WHITE TANKS NO. 3 & NO. 4 REPAIR

# WHITE TANKS NO. 3 REPAIR

INDEX OF DRAWINGS
WHITE TANKS NO. 3 REPAIR
WHITE TANKS W.P.P.
MARICOPA COUNTY, ARIZONA

# WHITE TANKS NO. 4 DRAIN

SECTION A 3 3

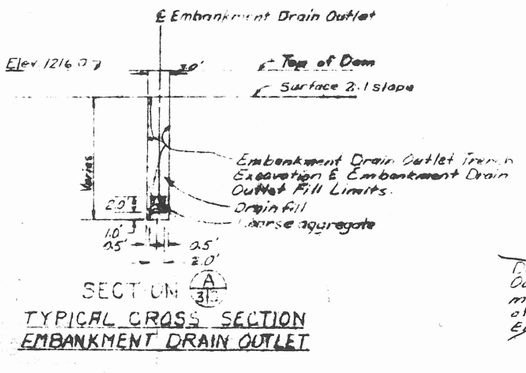
~~SCHEDULE OF EMBANKMENT DRAIN OUTLETS~~

~~REVISED~~ SCHEDULE OF EMBANKMENT DRAIN OUTLETS

| REVISIONS | | |
|---|---|---|
| 12-18-81 | Revised Schedule of Embankment Drain Outlets. See attached list of outlet stations. | WEP |

see sheet 4
